MAINTENANCE MANUAL

IF-DETECTOR BOARD 19C321662G1-G3, G7-G9

ADDENDUM #1 TO LBI30049F

This addendum contains information on IF-Detector board 19D432538G1-G6. The IF-Det board used tuneable IF transformers to facilitate alignment and troubleshooting. Changes in the IF alignment and circuit analysis of the IF-Det board are contained in this addendum.

IF DETECTOR BOARD
19D432538G1-G6

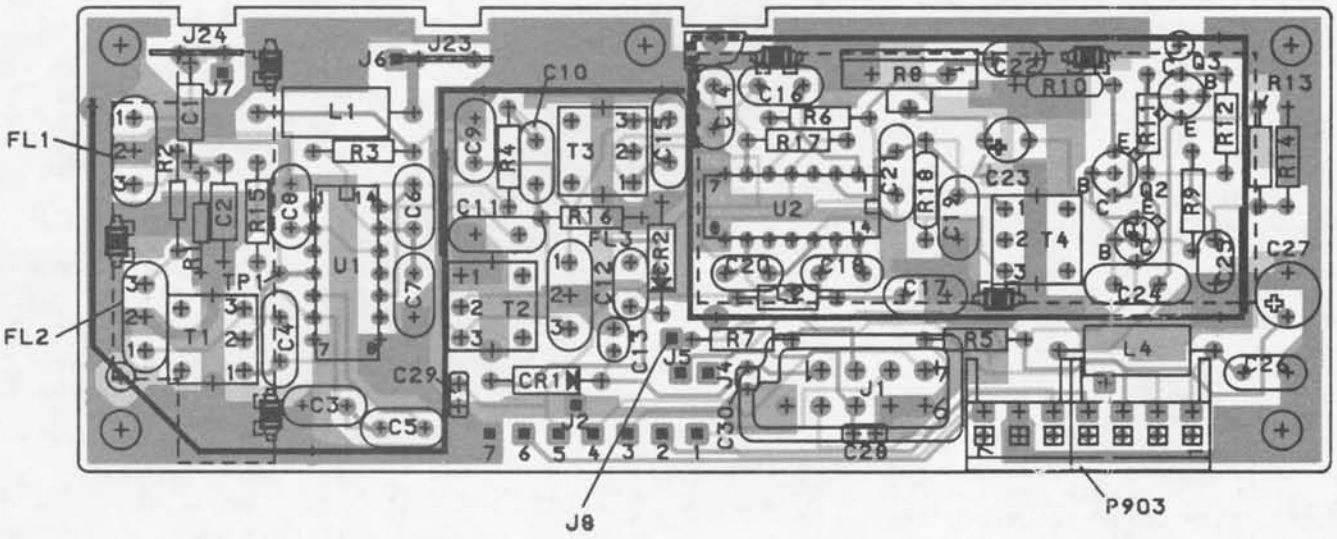
REV. A - IF Detector Board 19D423538G1-G6
To improve operation at temperature extremes. Added R618.

REV. B - To correct frequency response at 100 Hz. Change C623. C623 was: 19A116080P109, Polyester: 0.22 µf ±10%, 50 VDCW.

REV. C - To provide an electrical connection for Digital Channel Guard. Added J608.

IF DETECTOR BOARD
19D432538G1-G6

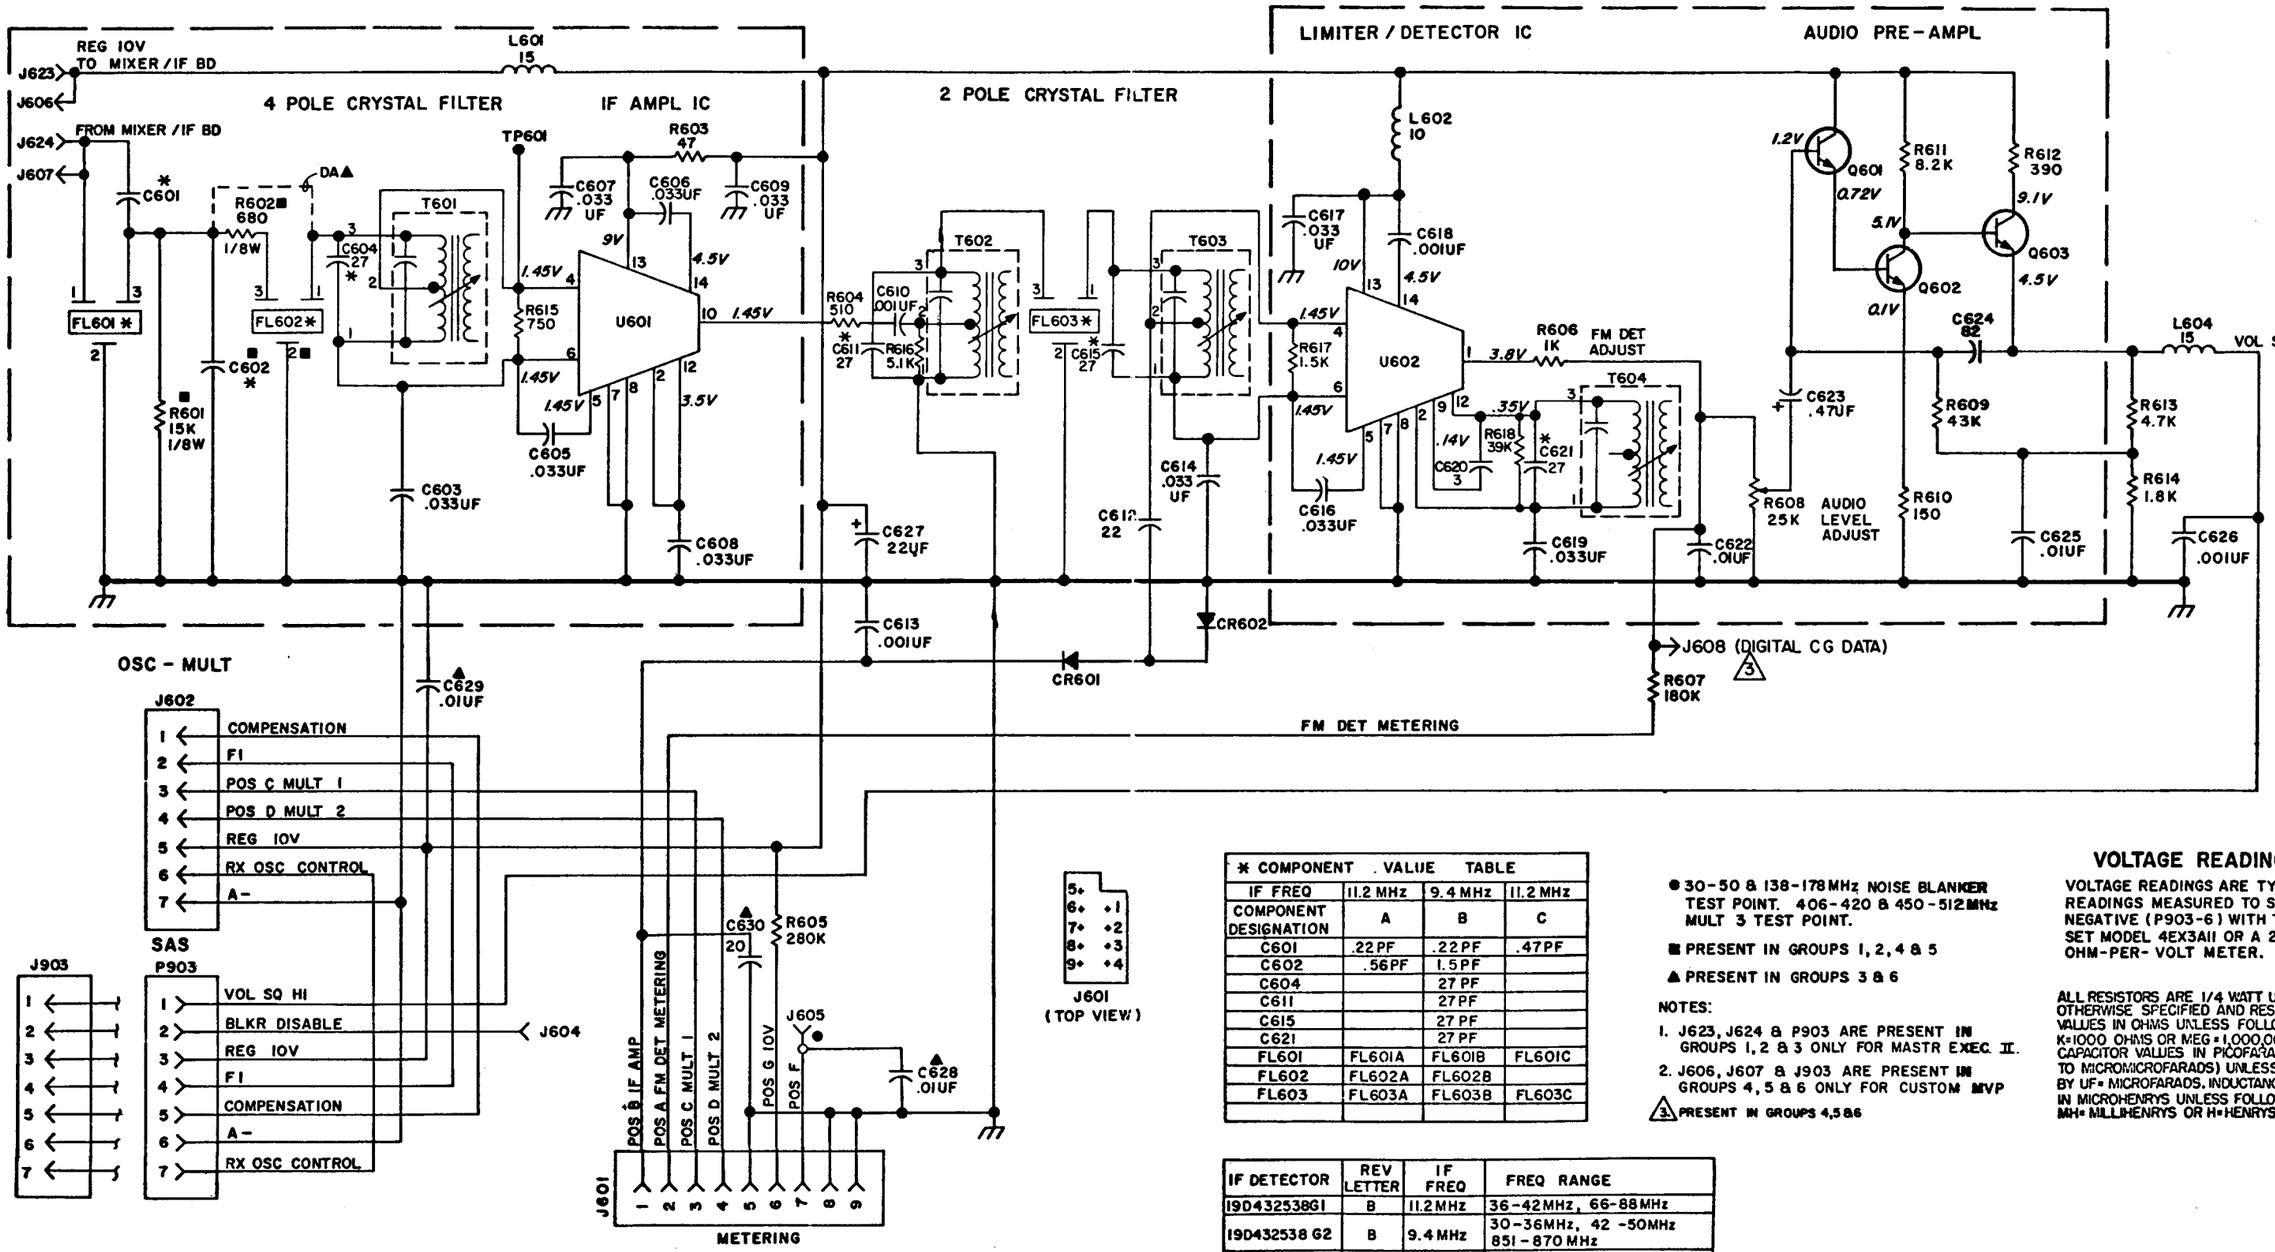
The IF input from the MIF or IF Filter board is applied to monolithic crystal filter FL601 and FL602. The cyrstal filter provides additional selectivity and is followed by a tuneable impedance matching network (T601) and IF amplifier U601. The IC amplifier provides approximately 60 dB gain.

Final IF selectivity is provided by two-pole crystal filter FL603. A tuneable impedance matching network T602 matches the output impedance of IF amplifier IC U601 to the input of crystal filter FL603. The IF amplifier output is metered at J601-1 through a metering network consisting of C612, C613, CR601 and CR602. Tuneable impedance matching network T603 matches the output impedance of FL603 to the input of Limiter-Detector IC U602.

The detector output is adjusted for maximum audio output by FM DET ADJUST T604, and is metered at J601-2 through R607.

When adjusting the FM detector, substitute T604 for L603 in the Complete Receiver Alignment.

After completing the Mixer-IF alignment steps, set cores of T601, T602 and T603 to top of coil form. Then tune T601, T602 and T603 for double trace as shown on scope pattern in the Complete Receiver Alignment. Reduce generator output as required to keep full waveform on scope.
